Access Compliance Report

Public Rights-of-Way

(Pedestrian Signals)

Intersection ID: N/A	Main Street:	Cross Street: N/A	Location: N/A
ADA ID: 7EC80053296B	Signal Type: One Push Button-APS	Overall Compliance: No	Severity Score: BTN 1: N/A BTN 2: N/A No BTN: N/A
Codes/Mitigation Info/Possible Solution		Field Measurements/Component Compliance

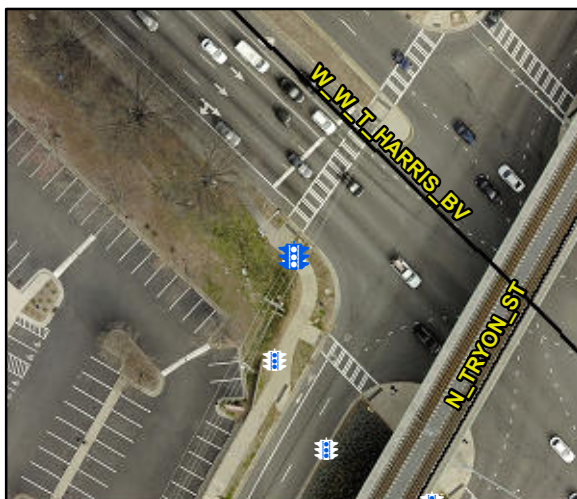
Surveyor Notes: NOT HOOKED UP, NOISES
AND VERBAL COMMANDS UNKNOWN

PROW/ADA: R404.2, R404.3, R404.7.3,
R404.7.2, R209.1, MUTCD 4e.10, R104.2,
MUTCD 4e.08,

Possible Solutions: Remove & Replace
Replace APS Button With New APS Button.
Remove and Replace Clear Space.
